Project: IEEE P802.15 Working Group for Wireless Personal Area Networks (WPANs)

Submission Title: Proposed Resolution of Some TG6 UWB PHY Comments

Re: Response to IEEE 802.15.6 Letter Ballot comments

Abstract: This document proposes a resolution for Letter Ballot 55 comments, specifically for the UWB PHY subclause.

Table 52 — PHR information structure

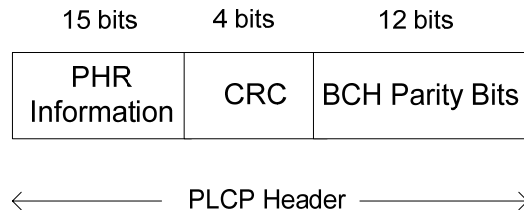
- **Comment:** The PHY header (PHR) is 31 bits in length based on the BCH (31,19) code, and is not compatible with the non-coherent UWB PHY mode (Sec 10.11.3). More specifically, the length of the PHR (31 bits) is not aligned to a symbol boundary of group PPM (GPPM). The symbol mapping of the GPPM is defined as 6 bits which are mapped onto 12 bits (or 1 symbol). Thus, a symbol consists of 12 bits and the number of information must be a multiple of 6 bits. Since the PLCP header is of length 31 bits, the last GPPM symbol would consist of 1 bit and 5 zero or pad bits. The 5 zero or pad bits contains no information and is just overhead.

- Problems with the current PLCP Header
 - The PHY header (PHR) is 31 bits in length based on the BCH (31,19) code, and is not compatible with the non-coherent UWB PHY mode (Sec 10.11.3).
 - More specifically, the length of the PHR (31 bits) is not aligned to a symbol boundary of group PPM (GPPM).

- **Proposed Change:** Modify the PHR structure to one of the followings:
 - 1) PHR information is reduced to 14 bits and apply BCH (30,18) to have PHR of length 30 bits. 14-bit PHR information forms as follows -- data rate (bit 0-2), MAC frame body length (bit 3-10), HARQ (bit 11-12), scrambler seed (bit 13), *OR*

- 2) PHR information is 20 bits and apply BCH (36,24) to have PHR of length 36 bits. 20-bit PHR information forms as follows -- data rate (bit 0-2), reserved (bit 3), MAC frame body length (bit 4-11), reserved (bit 12-13), HARQ (bit 14-15), reserved (bit 16), scrambler seed (bit 17), reserved (bit 18-19).

Proposed Resolution: PLCP Header (1/2)

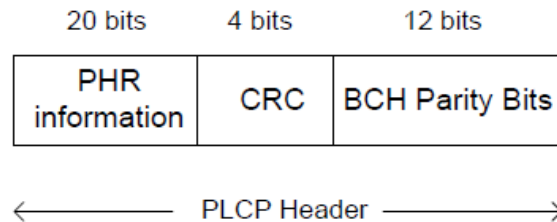
- **Comment:** 2 bits should be added to the PHR for transmitted waveform information. This should be done for the following reasons: 1. Hopping sequence generator clock is different when dynamic scrambling is used. Thus, receiver needs this information. 2. Some receiver architectures benefit considerably if transmitter waveform type is known, e.g. correlation receiver, chirp receiver. 3. Sample-wise Differential Detection technique can be successfully applied only if there is no dynamic scrambling. Thus, receiver needs to know if dynamic scrambling is applied or not.

- **Comment:** Table 52
- **Proposed Change:** Need to have more reserved bits for header as it may not be efficient to transmit just 256 octets at 10 Mbps
- **Proposed Resolution:** Accept comment S10-105. Add 2 reserved bits right after “MAC Frame Body Length” in the PHY Header. See Slide 8 for proposed PHY Header that include 2 reserved bits right after “MAC Frame Body Length”.

- Accepted comment S10-18 in principle. Use a shortened BCH (36,24) code, where the shortened BCH (36,24) code is a shorten code derived from BCH (63,51)
- Proposed PLCP Header structure

- Proposed PHR Information Structure

Bit	1	2	3	4	5	6	7	8	9	10	11	12	13	14	15	16	17	18	19
0																			
R0	R1	R2	R	L0	L1	L2	L3	L4	L5	L6	L7	R	R	B	W0	W1	H0	H1	S
Data rate			a	MAC Frame body length								a	a	b	Waveform		HARQ		c

Spectrum* with Chip-Level Scrambling

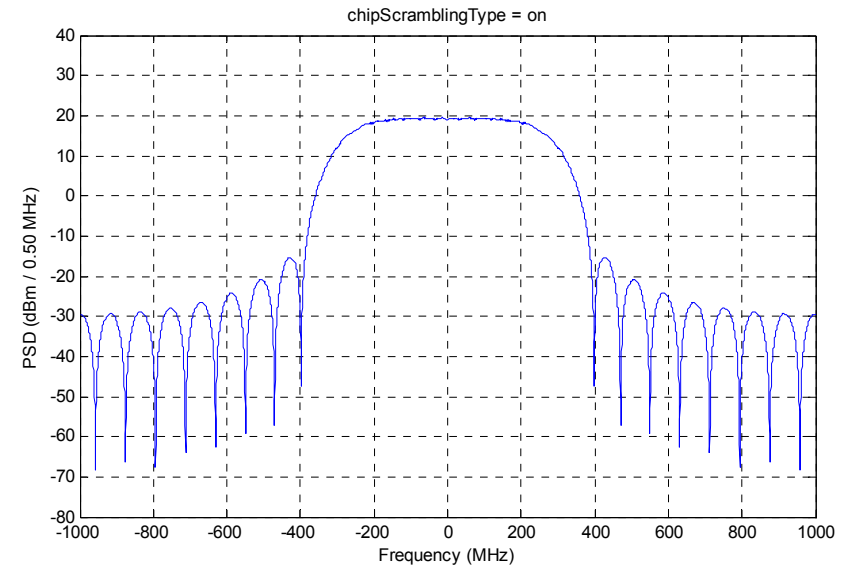
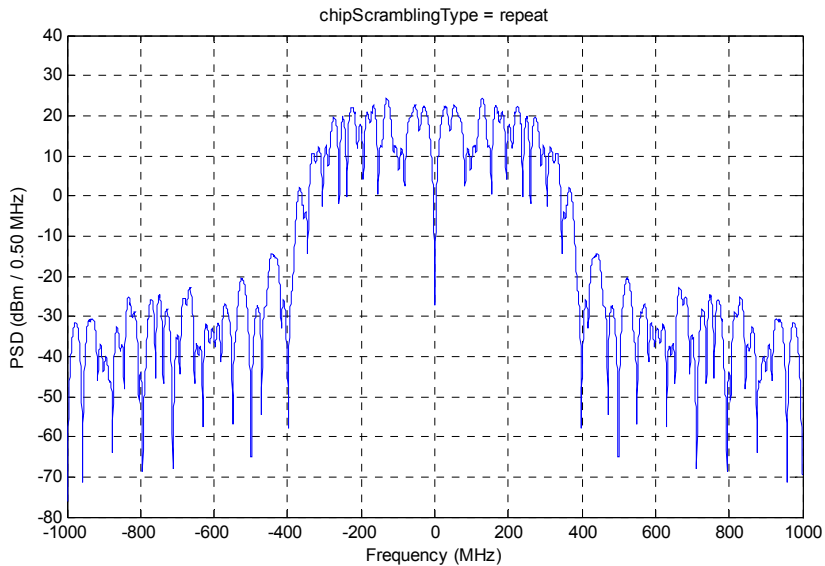
- **Comment:** Static chip-level scrambling specified in the section is using a fixed scrambling sequence repeatedly in each symbol, which creates severe spectral lines in the transmit spectrum. Need to check link budget analysis by taking necessary backoff that is required by static scrambling into account. High/medium data rates very likely have issues with the transmit power backoff (to meet the spectral mask) that would be required by static scrambling.

- Scrambling code is repeated in each symbol
→ Ripple over the passband is about 20 dB
- Scrambling code generated by an LFSR
→ Chip-level scrambling enables the most desirably flat spectrum.

- **Proposed Resolution:** Accept comment S10-178. Apply dynamic chip-level scrambling specified in Section 10.11.1.1 as mandatory in all the PHY modes that use short-pulse waveforms.
